Product Change Notification - GBNG-06ZLHV932

CCB 3843 Final Notice: Implement Microchip Packing Changes for selected Microsemi (LCLD, VPT, TIM, WIFI) products.

Final notification

Manufacturing Change

Moisture Barrier Bag (MBB)-Tube

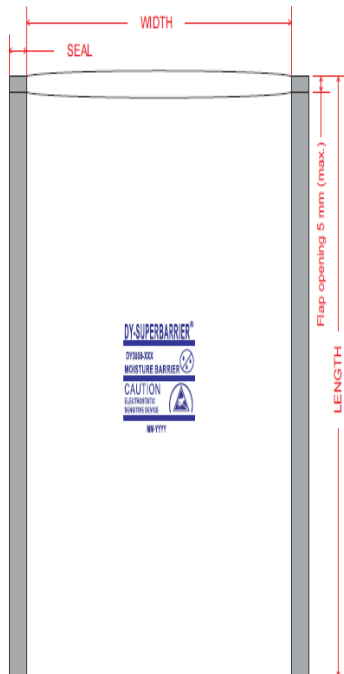
Packing media	Subon	Dimension W x L (mm)
Tube	ASEM	254 x 762

Part no.	Dimension W x L (mm)
24000039	200 x 670

Moisture Barrier Bag (MBB)-7" TnR

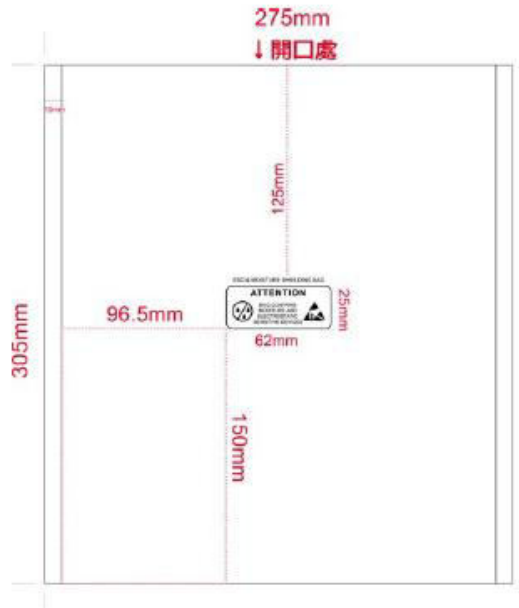
Packing media	Subcon	Dimension W x L (cm)
7" TnR	GIGA	275x305

Part no.	Dimension W x L (cm)
24000046	220 x 300

Moisture Barrier Bag (MBB)-13”TnR

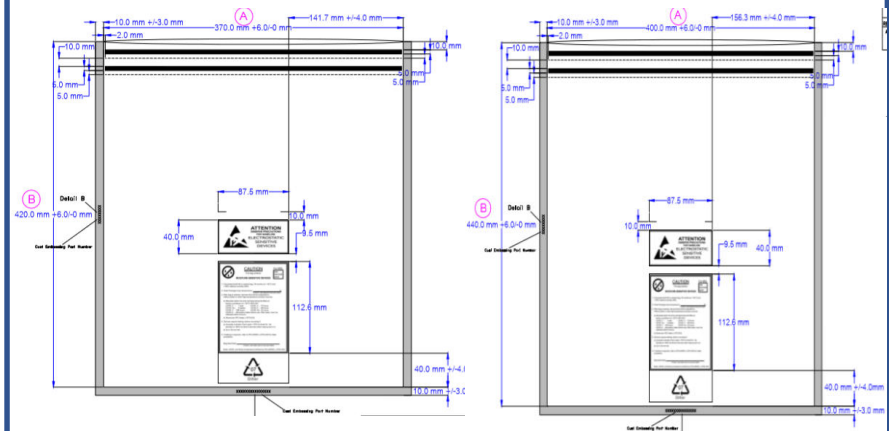
Packing media	Subcon	Dimension W x L (cm)
13”	ASEM	406.4 x 457.2
	UTAC	380 x 445
	GIGA	400x430
	SIGURD	400 x 450

Part no.	Dimension W x L (cm)
24000001 (Small)	370 x 420
24000006 (Large)	400 x 440

Inner Carton for Tray

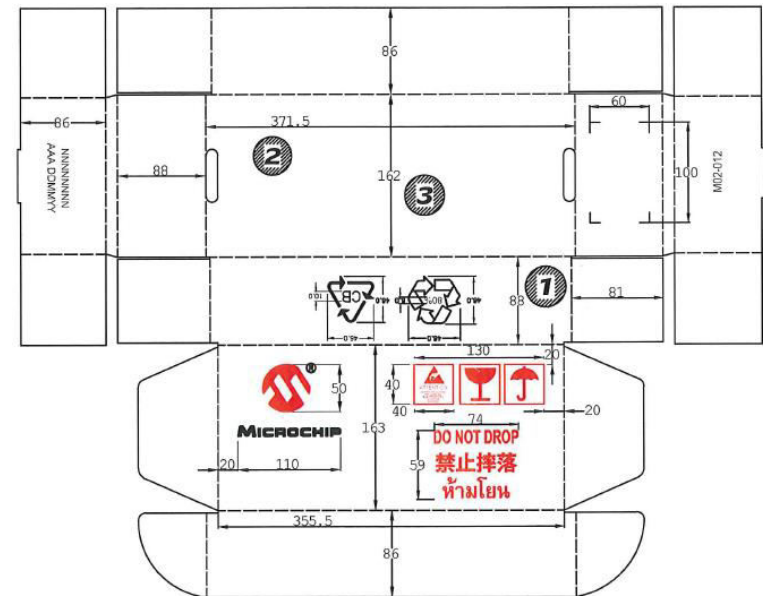
BU	Subco n	Drawing number	Dimension W x L x H (cm)
LCLD, VPT, TIM	UTAC	26030055	16X36X10.5
	ASEM	11407522	17.8X38.1X11.5

Drawing number	Dimension W x L x H (cm)
M02-012	16.2x37.1x8.8

Tray Outer Carton (2:1)

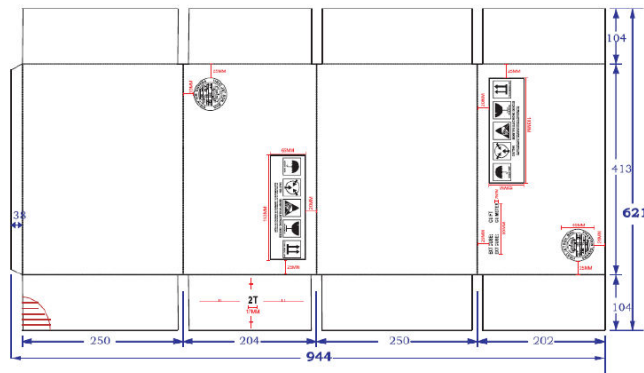
ASEM 2T CARTON DRAWING (250 x 204 x 413 mm)

Width	Length	Height
37.0	38.0	11.0

Outer Carton for Tube (1:1)

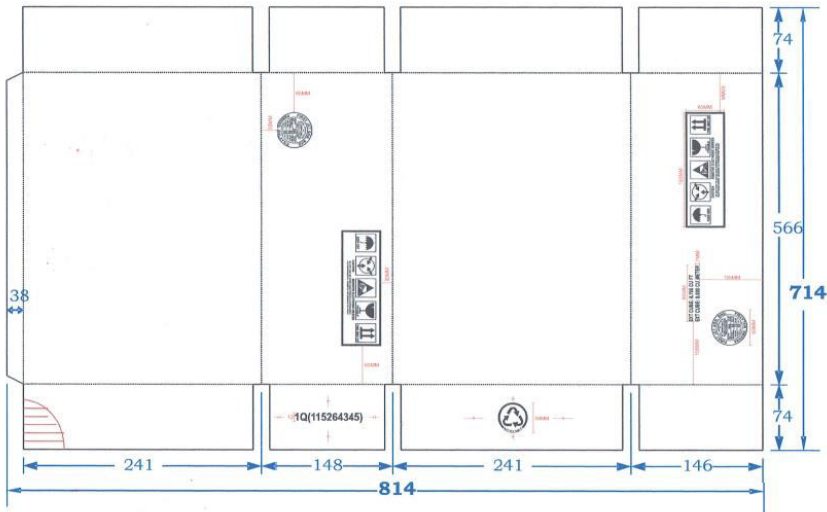
BU	Subcon	Drawing number	Dimension W x L x H (cm)
LCLD, VPT, TIM	ASEM	115264345	24.1x56.6x14.8

Drawing number	Dimension W x L x H (cm)
M01-022 (PP)	15.5x62.0x14.0

Outer Carton for Tube (2:1)

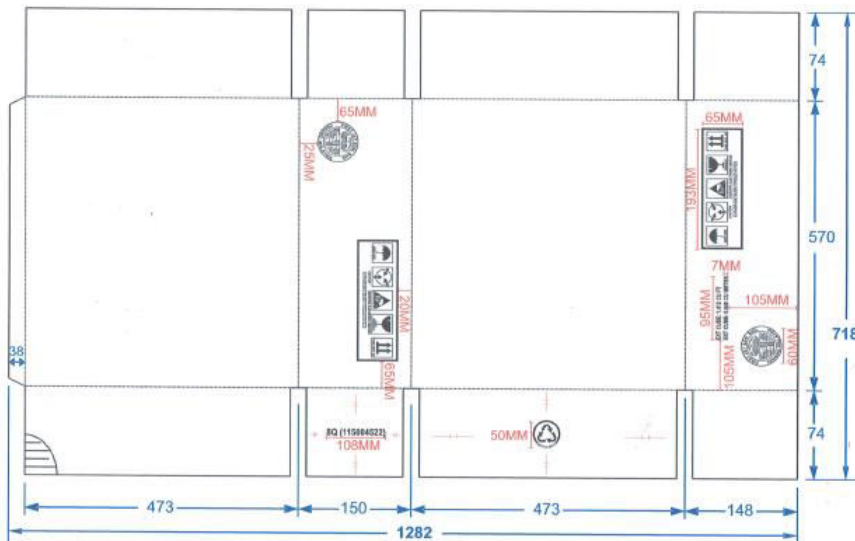
BU	Subcon	Drawing number	Dimension W x L x H (cm)
LCLD, VPT, TIM	ASEM	115004522	47.3x57.0x15.0

Drawing number	Dimension W x L x H (cm)
M01-028 (C4)	28x63.5x11

Outer Carton for Tube (4:1)

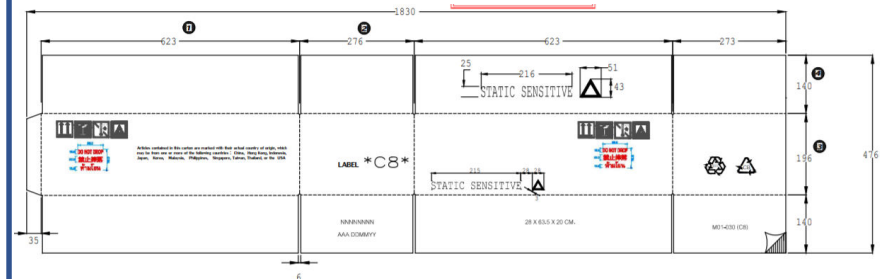
BU	Subcon	Drawing number	Dimension W x L x H (cm)
LCLD, VPT, TIM	ASEM	115005522	47.3x57.0x28.1

Drawing number	Dimension W x L x H (cm)
M01-030 (C8)	28x63.5x20

Outer Carton for Tube (6:1)

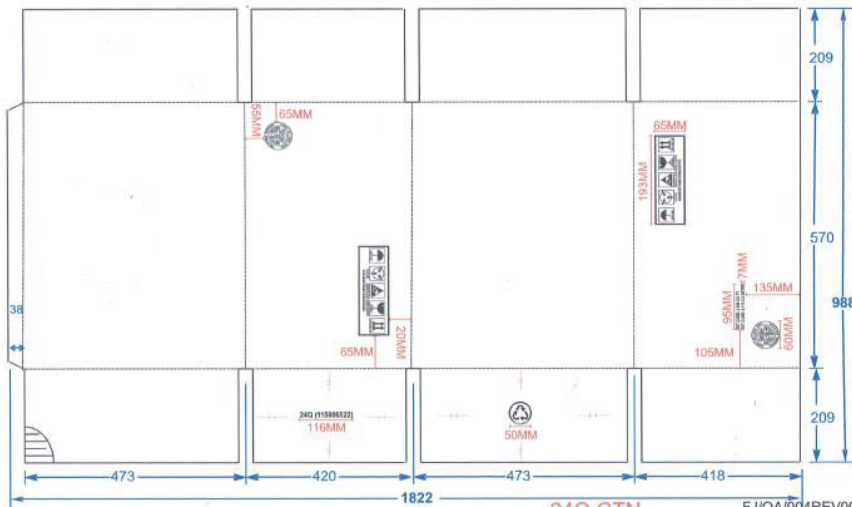
BU	Subcon	Drawing number	Dimension W x L x H (cm)
LCLD, VPT, TIM	ASEM	115006522	47.3x57.0x42.0

Drawing number	Dimension W x L x H (cm)
M01-040 (S6)	43x59x19
